## **TRAFFIC CALMING CONSULTATION**

June 2008

This document summarizes the findings of a village consultation held on June 22<sup>nd</sup> and 23<sup>rd</sup> at The George Inn concerning the following Lochailort traffic calming proposals:

Figure 1 (Comments Received)

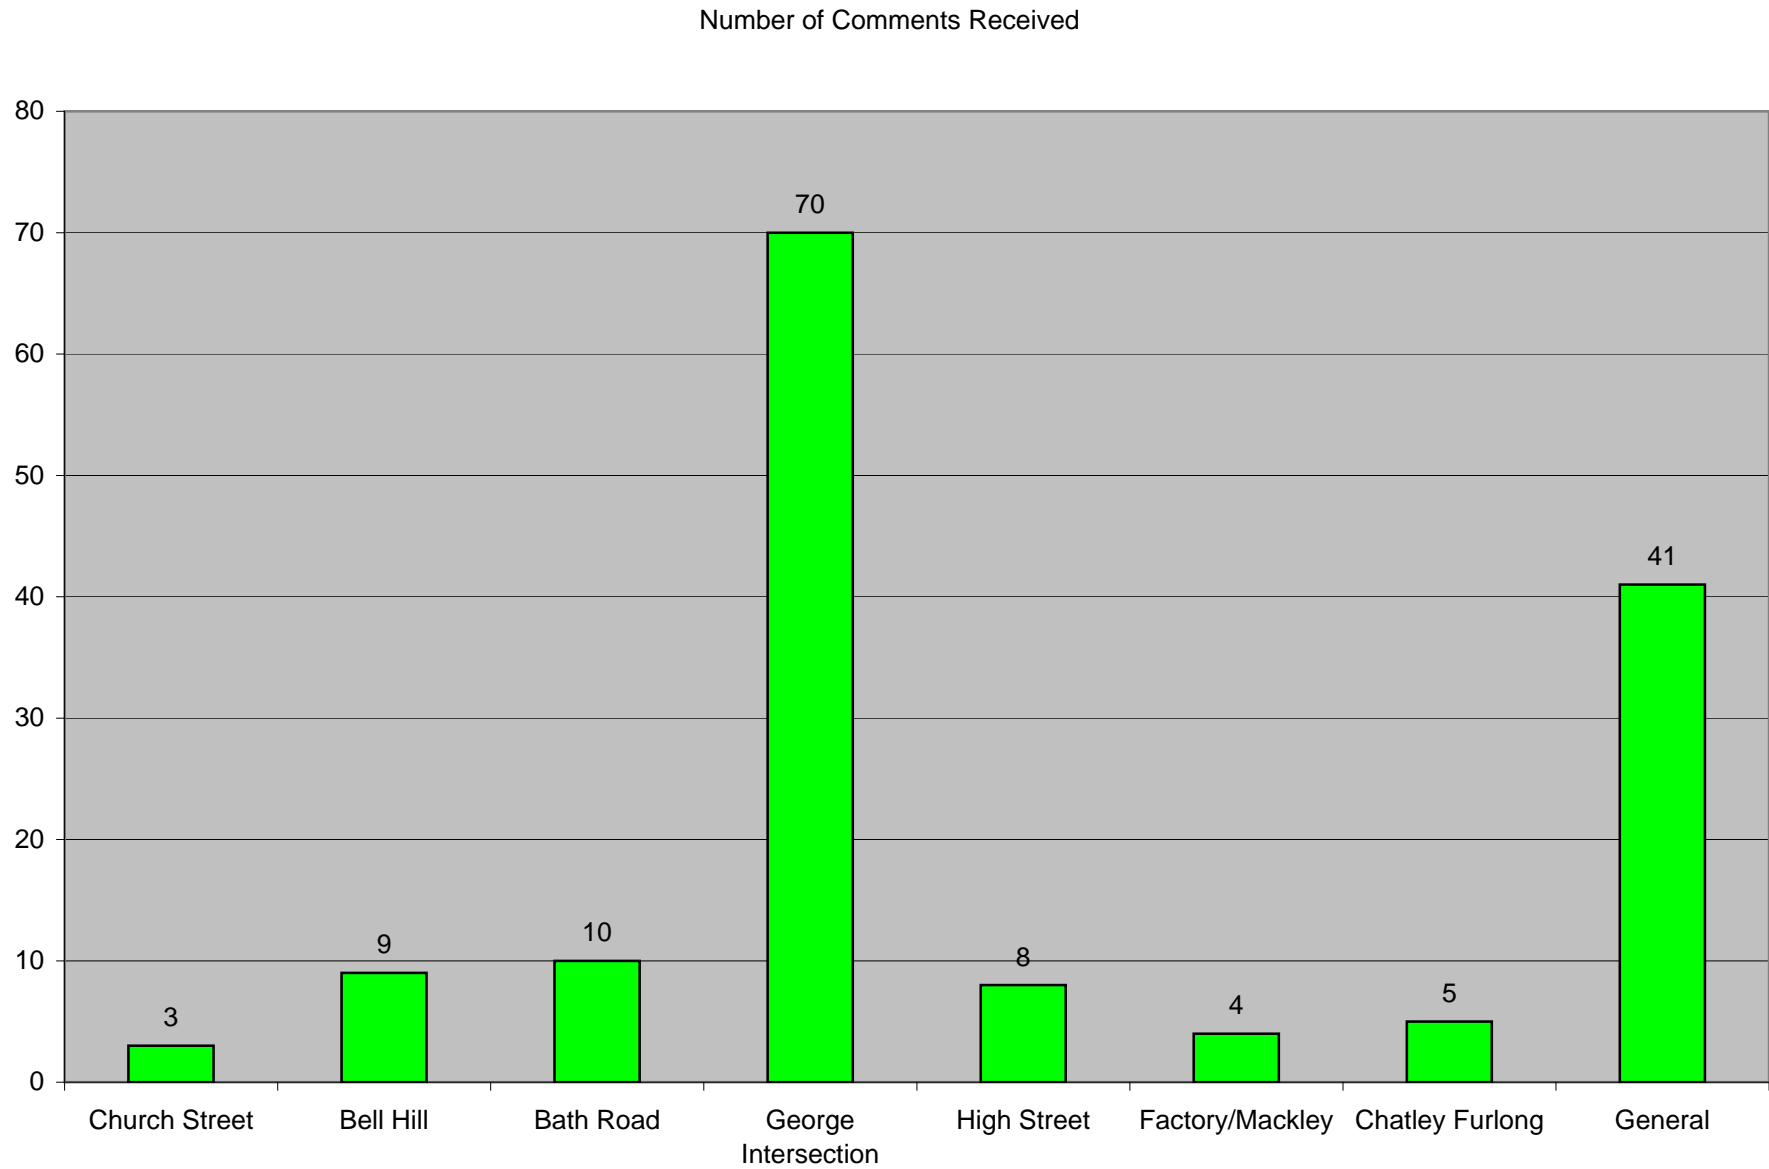
The number of general comments and those received for each zone were charted, which showed nearly half relate to The George intersection (Figure 1). The number of general comments also significantly exceeded those for the other zones.

Figure 2 (First Priority Votes)

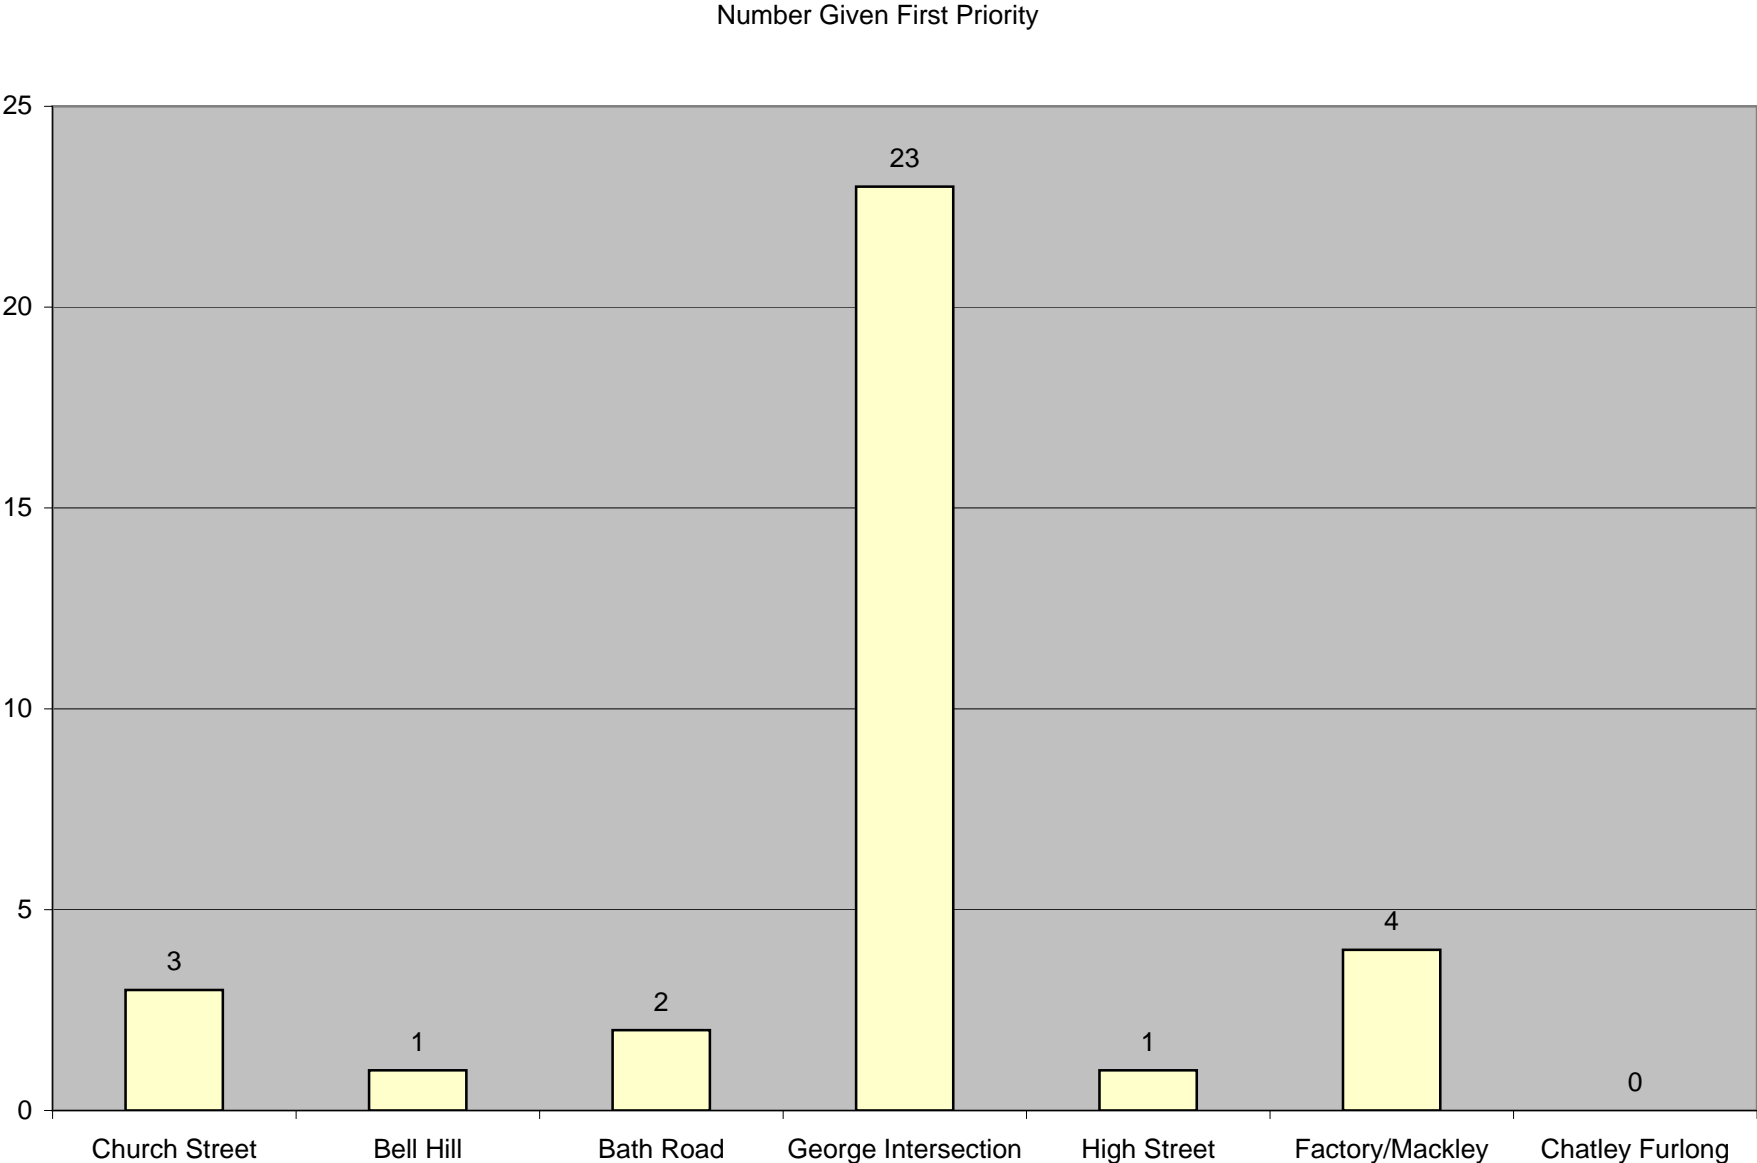
In terms of priorities for funding, the George Intersection was considered the first priority by a wide margin (Figure 2). Moreover, when all first, second and third priority votes are charted, Church Street and the chicken factory entrance and Mackley Lane emerge as the next favoured for funding (Figure 3).
